Subject: National Highways response: A/256/21/RES (layout amendments) - Land North of Water Lane, Angmering

Planning Application No: A/256/21/RES

Site: Land North of Water Lane, Angmering

Proposal: Approval of Reserved Matters following outline consent A/248/21/PL for the erection of 525 No residential dwellings with associated parking, landscape, play areas & public open space (amendments to the layout).

Figure 2 – Existing National Highways Drainage along the A27 in proximity of the development site

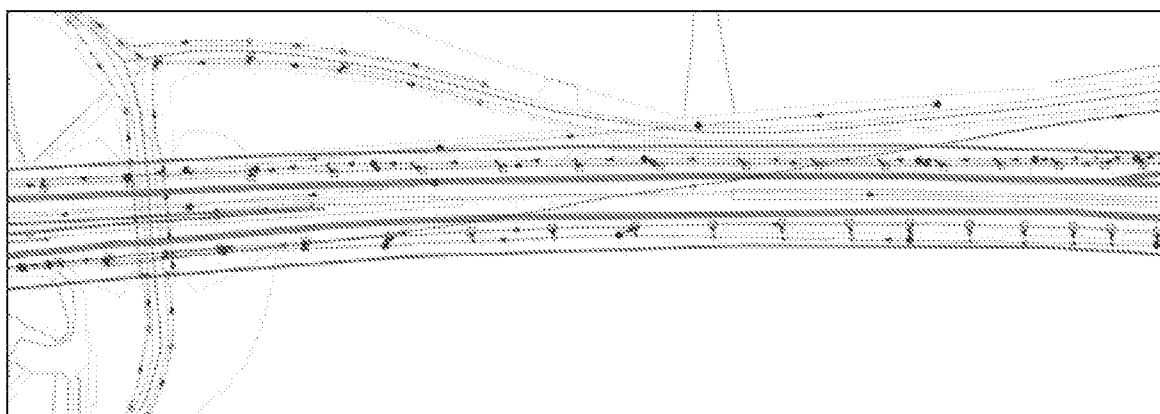
The existing National Highways drainage is running along the A27 (Westbound) adjacent to the proposed development, as shown in Figure 2 below.

ACTION: The applicant must advise on the mitigation measures to ensure that the existing drainage along the A27 (Westbound) carriageway is protected while groundwork and erection of a bund is undertaken. Root protection must also be assessed given the trees proposed to be planted in proximity of existing drainage channels.
